Wiring Change –  
Driver Seat Control Module –  
Modification Instructions

MODEL 1997 MY  
XK8 Range  
VIN 001001-003300

ILLUSTRATION 1

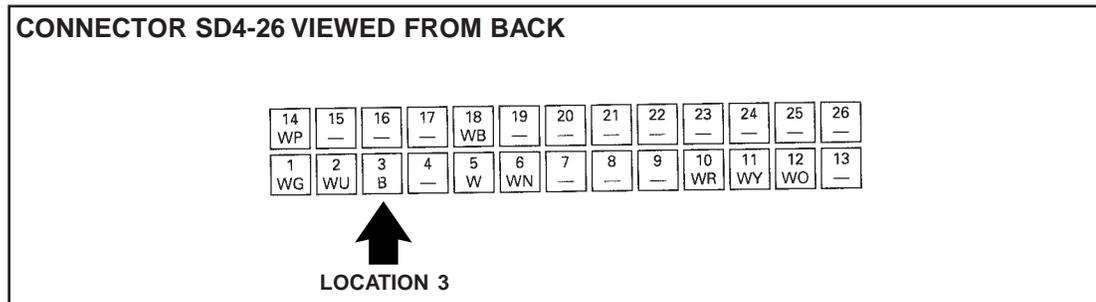
2. Disassemble the SD4/26 center connector to remove the black wire from location 3 (Illustration 1). Verify that the black wire is connected to body ground.
3. Reassemble the SD4/26 connector.
4. Remove the terminal from the black wire. Splice on a lead with a molex connector terminal already crimped on (part no. 418-083 supplied in the wiring harness repair kit 418-S065).
5. Pull out the red lock on connector SD5/10 to unlock the terminals.

ILLUSTRATION 2

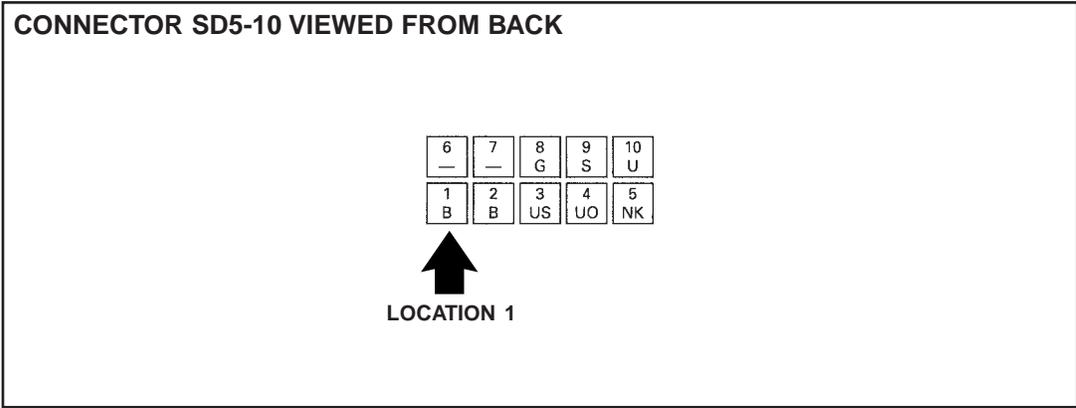
6. Install the new terminal that was joined to the black wire in position 1 on the SD5/10 connector (Illustration 2). Press the red lock back into position.
7. Connect and install the new DSCM.
8. Reconnect the battery.
9. Verify proper operation of all seat and memory functions.
